277 Bigge Street Liverpool (DA507/2018) — Peer Review — Heritage

I refer to my engagement by Liverpool City Council (LCC) to undertake a peer review of the heritage impacts of the above Development Application (DA) and the adequacy of the associated heritage documentation.

Figure 2 Looking towards the development site from Light Horse Park. I believe that part of Light Horse Park will be overshadowed in late afternoons in mid June

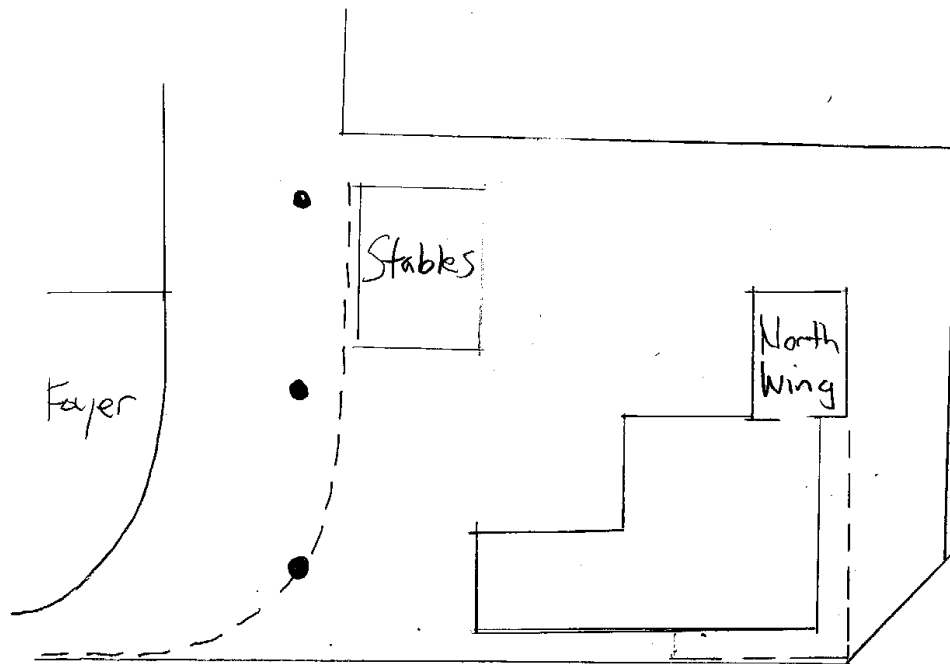
5.3 The Design Report includes shadow diagrams on p124 that show the three heritage items across Scott Street will be overshadowed for a good part of the day in mid-winter and that in the late afternoon so will part of Light Horse Park.

Figure 3 Current building on Scott Street that should be archivally recorded as a condition of consent for any DA approval

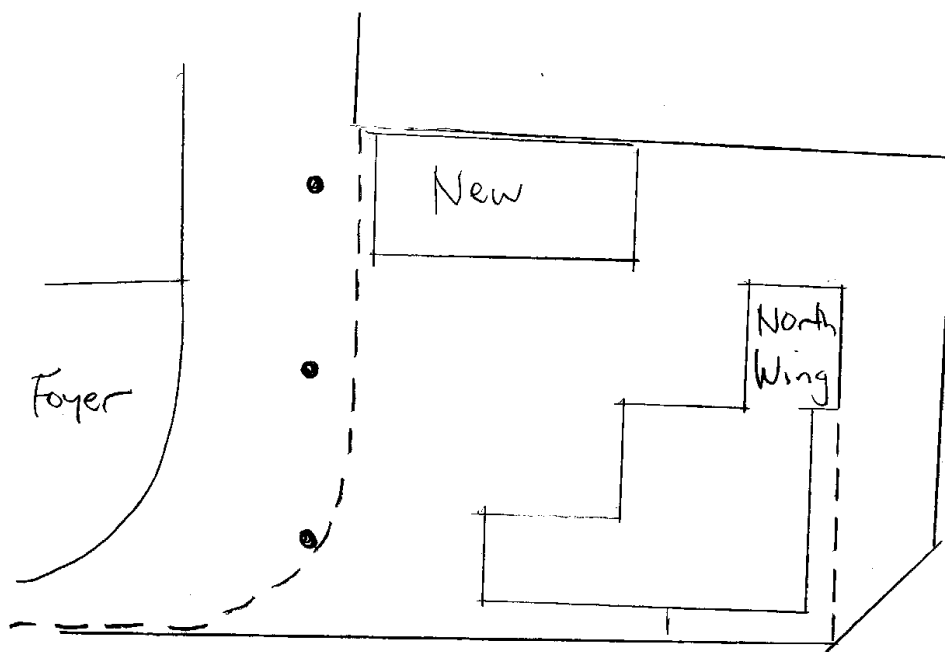
6.4 While not heritage items, some of the structures proposed for removal are good representative Art Deco Inter-War shopfronts and I believe that the existing streetscape and these structures should be photographically archivally recorded prior to demolition, as a

A full photographic archival record should be made of all the structures on the full development site including all structures proposed for removal.

Commercial Hotel site development options to retain heritage values: Option 1 is the ideal heritage outcome and retains both the Stables and the Northern Wing. Option 2 retains some heritage values with the retention of the Northern Wing but the significant Stables is removed.

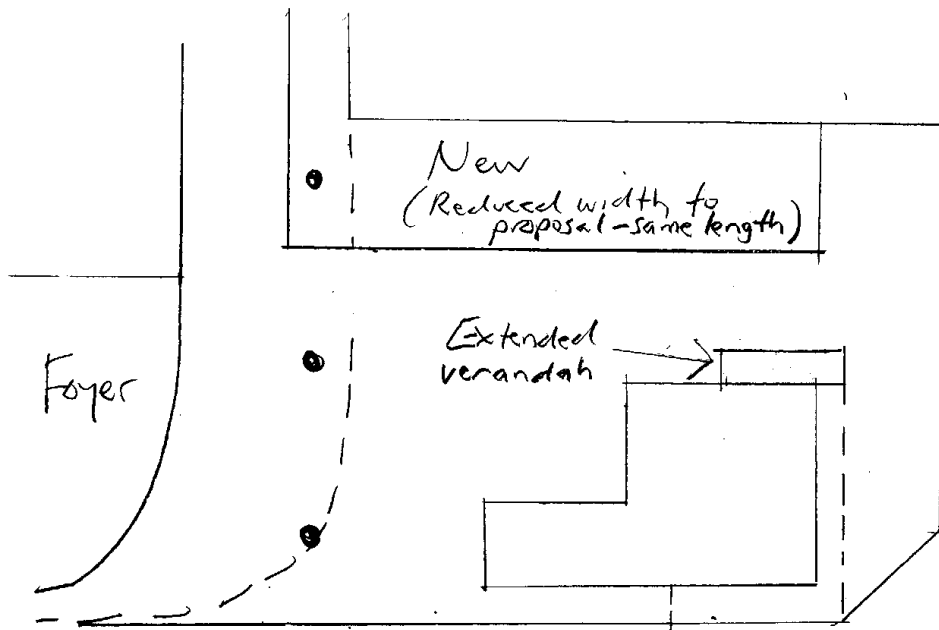
I believe the proposed scheme should have considered the retention and adaptive reuse of the Stables (see Attachment 2). I accept that their retention would require a redesign of the tower scheme as currently there is a basement area under the Stables site. If the Stables were retained this would create a far more interesting, intimate and authentic urban space than what is proposed.

While this would see the removal of the Stables, it is recognised that the DA development has progressed over some time without consideration of the retention of the Stable and its retention now would impact the scheme as evolved. Given that, this option is also reasonable as it will retain the early form of the Hotel and its streetscape presence and contribution.

Option 1: Retain stables & north wing

Option 2: Retain North Wing

The ideal heritage outcome would be Option 1, together with the internal changes to the first and second floors noted in 8.4.

Option 3: Extend two level verandah
- see view below.

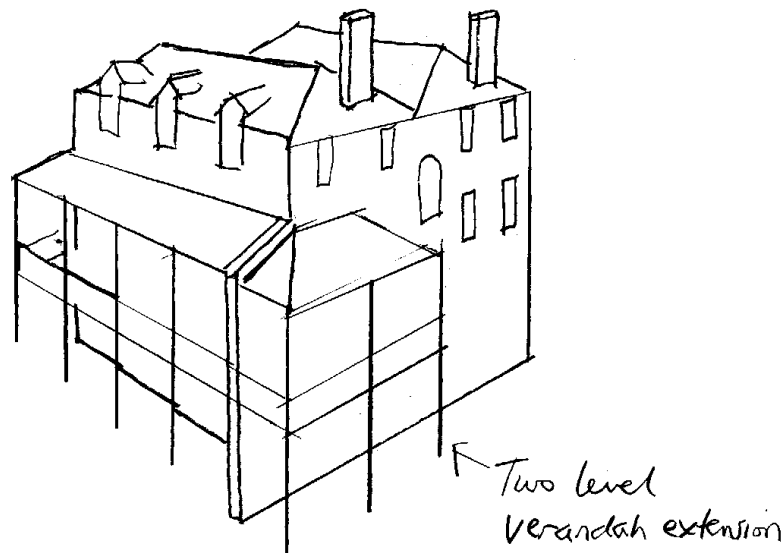
I believe that rather than a modern fabric awning attached to the ground level on the northern elevation that if the Northern wing is removed that a two-level verandah should be added on the north elevation to provide a stronger three-dimensional form and streetscape presence and to complement the verandah at the south end. This would mitigate to some extent the impact of the removal of the Northern Wing and avoid the diminishing and truncated frontage to Bigge Street that the proposal provides. While the existing first floor space (FF16) that connects the stair case to the upper level of the northern wing provides a starting model for how a verandah could be added to this elevation (see Attachment 1, Figure 4), I recommend that the wrap around verandah be at the same height as the existing to Bigge Street verandah to provide a more consistent and coherent verandah form.

In preparing the site options I concluded that the proposed New Stable is located too close to the Hotel at its eastern end and should be required as a condition of consent to be 1.2 narrower — this is shown indicatively on Option 3.

That the proposal be amended to include a two level verandah addition to the north elevation of the Hotel as a mitigative measure to the impacts on the overall hotel form, its streetscape presence and on Bigge Park Conservation Area that will result from the removal of the Northern Wing. This two-level verandah should respond to the existing in height width and form and fabric of the existing verandah but also be recognisable in close inspection as new work (eg a simplified balustrade cast iron pattern). The verandah should start at a retained dividing wall at the end of the verandah on Bigge street and return along on the northern façade at least up to the curved upper level window above the staircase. The verandah should conform generally to the structure shown on the view on Option 3 Attachment 2. Liverpool City Council and its heritage advisors are to be satisfied as to the design and extent of the proposed verandah addition.

That the proposal be amended to reduce the width of the NeW Stables at the eastern end in the vicinity to the Hotel to provide a better spatial setting for the Hotel and a less crowded access way than that shown. (Note that the verandah above will in general terms require no more depth than the new fabric awning shown in the proposal.)

Attachment 3

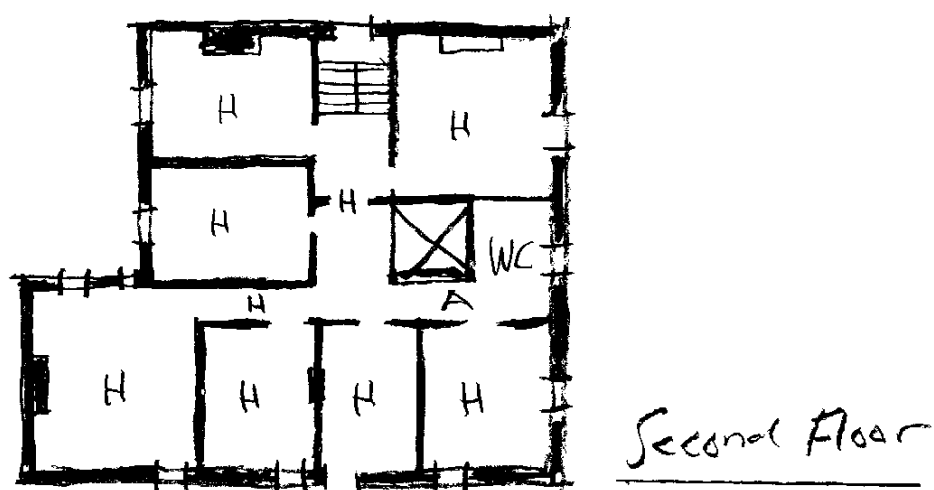
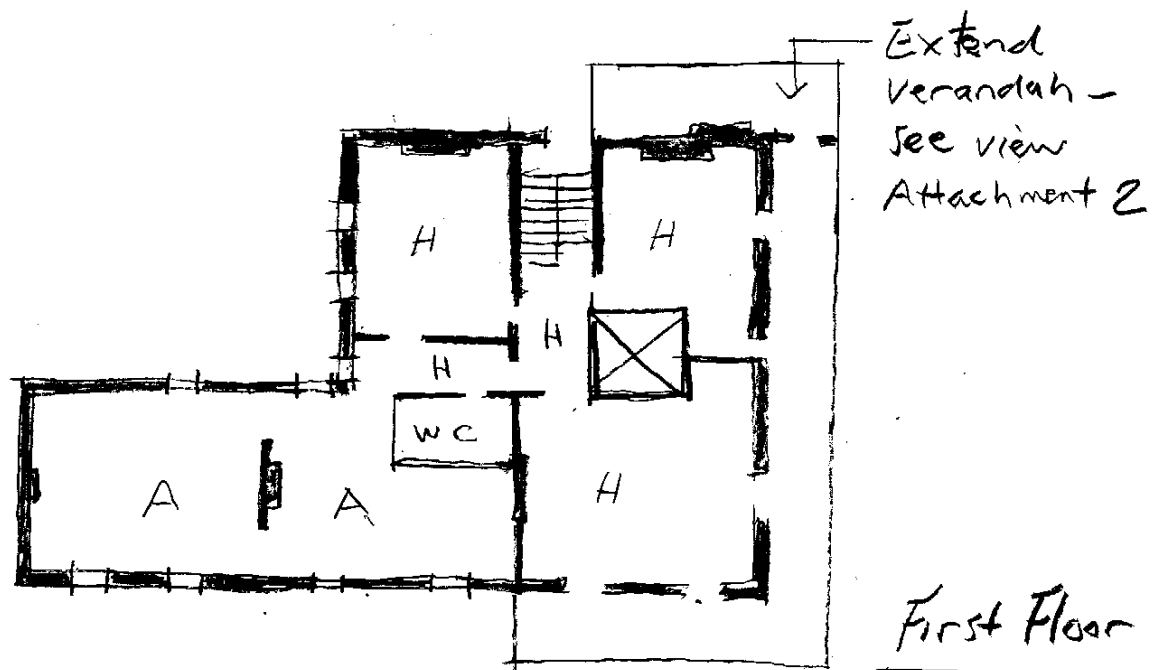
It is agreed that residential accommodation in the hotel is not likely to be a viable future use. However, I do not accept that as a retained item on a large commercial tower site that it needs to be gutted on upper levels for an open span use — a more innovative design approach is needed. In this situation the retention of significant spaces and fabric should determine the nature of the new commercial use — not a new commercial ‘norm’ of open space being the determinant. The assumption of large open work spaces is questioned over the opportunity to provide a range of spaces that can be used by sole traders with some shared spaces. A more creative response would be to retain the circulation corridor spaces (including the arches and

walls adjoining the staircases and halls) while removing a few internal walls (including recent bathroom insertions) while retaining nibs of the removed walls. Attachment 4 is a sketch plan I have prepared. The First floor could have three of the larger bedroom spaces retained and three of the Scott Street frontage rooms linked as a space together and with the retained central and east west hall. On the Second floor seven bedrooms can be retained together with both the central and the east-west hall. On both levels the proposed lift and a DDA toilet are provided.

H = Heritage Space retained
A = Heritage space adapted
Not to Scale

Sketches showing alternative designs to the proposal to indicate how heritage spaces and fabric can be retained on the first and Second floors of the Commercial Hotel while providing for new uses. On the first-floor circulation halls and arches are retained along with three former bedroom spaces and with a larger shared space on Scott Street. The second floor has all circulation spaces and arches and all except one-bedroom space retained. On both levels a lift and accessible toilet is provided.

It is recommended that any consent for the current proposal exclude approval for the use and changes to the interior of the First and Second floors of the Commercial Hotel and that a further DA be required to be submitted for Liverpool City Council approval for the use and adaptive reuse changes and to be in accordance with the intention of the sketches that form Attachment 4 to this report (see 8.4) to retain existing circulation spaces (including halls and dividing walls and arches) and the spaces of existing bedroom spaces generally while providing for some limited enlarged areas with partial wall removals and also providing for a lift and accessible toilets on both levels, once again generally in accordance with the intent shown on the sketch plans in Attachment 4 to this report.
